NEAH BAY SECTION 107 NAVIGATION IMPROVEMENT PROJECT NEAH BAY, WASHINGTON

APPENDIX H PUBLIC COMMENTS

September 2020

Comment Set 1, Submitted by the Washington Department of Ecology on 12 August 2020:

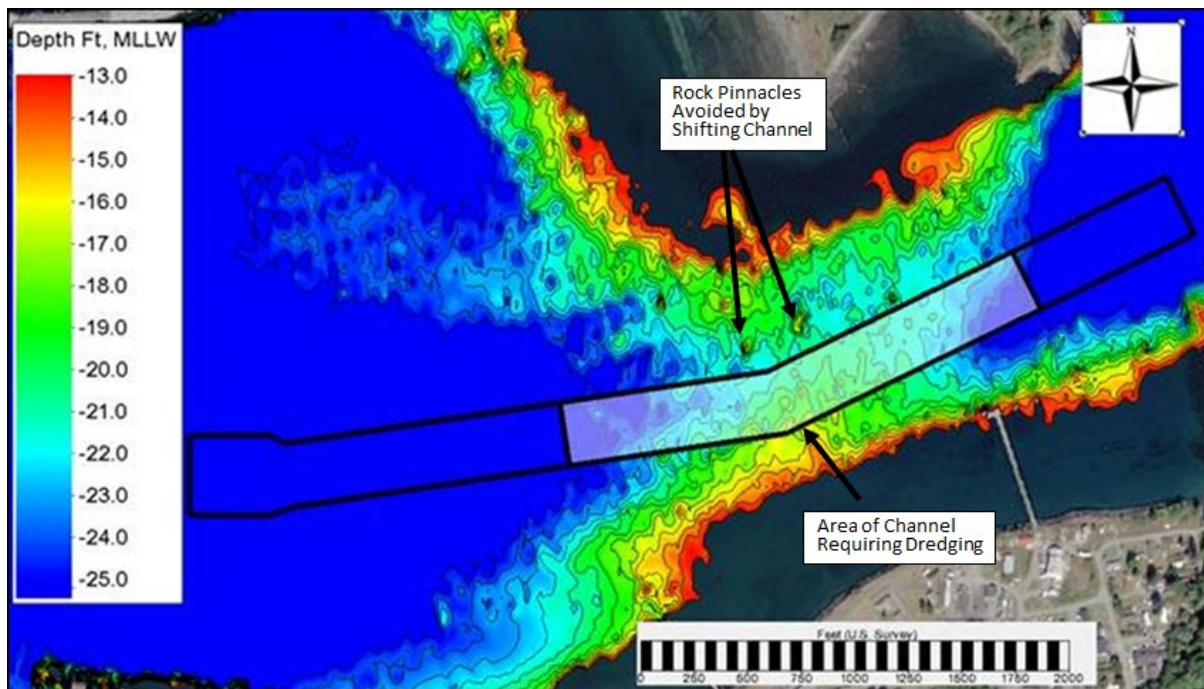
a. Several times, the three creeks in the area are mentioned, but I did not see them on any map. It would be helpful to include them on Figure 1-2.

3. Figure 1-2. Please add the following locations: Evans Mole, Village Creek.

USACE response: The confluences of both Agency and Halfway Creeks were shown on Figure 1-2. The Village Creek will be added to Figure 1-2 in the Final Feasibility Report/Environmental Assessment (FR/EA). See updated figure below:

USACE response: Done

(Figure 1-3) that shows the location of the rocky pinnacles and the location of the channel, which avoids this rock. See new figure below:

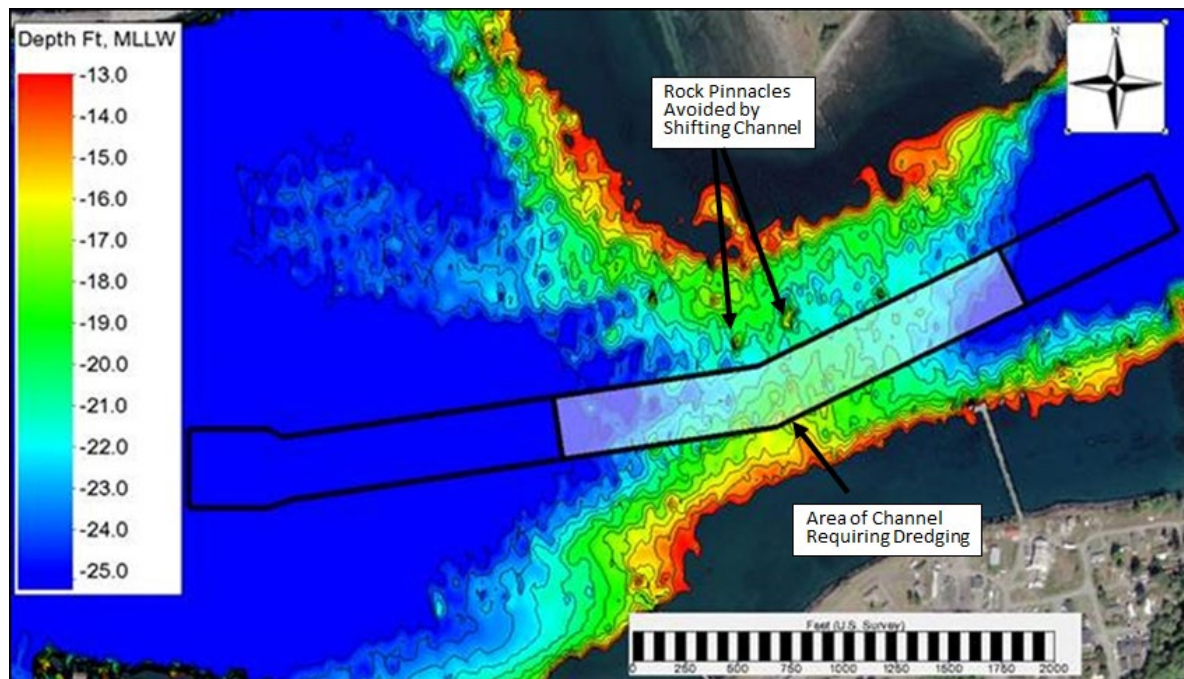
- c. The "Rock Pinnacles" are mentioned throughout the report, but other than Figure 1-4 cross section, they are not included on any maps. Can the figure in Appendix B be brought into a figure showing the rock profiles and proposed navigational channel footprint?

- d. Reference to the pinnacles say that the shallowest it is likely to be is -24. However, looking at the figure in appendix B, it looks like it is at -20 in some areas that may be in the proposed channel. (see below- convert to "rich text" if it doesn't show up)

2. Section 3.3. This section and footnote in Table 3-5 indicate rock may be encountered at elevations deeper than -22' MLLW or -21' MLLW respectively. Given the recommended project depth of -21' MLLW + 2' overdepth, how will rock be handled during hydraulic dredging?

4. Figure 1-3 and Section 3. Please add the location of the “rock pinnacle” to Figure 1-3.

USACE response: *Refer to new Figure 1-3 of the final FR/EA showing channel depths including rock pinnacles and channel alignment. Rock pinnacles were avoided by shifting the channel to south. See new figure below:*

USACE response: *Similar to previous response, reference new figure 1-3. The channel was shifted to the south to avoid the shallowest rock areas.*

USACE response: Based on the accuracy of the acoustic surveys, there is risk that there is rock within the overdepth prism. If rock is found during PED, when the Sediment Suitability Determination (SSD) will be done, we will reduce the overdepth dredging. This has been added to the footnote on table 3-5. Note that a new figure has been added to the Final FR/EA

USACE response: A new Figure 1-3 has been added to the Final FR/EA that shows the rock pinnacle.
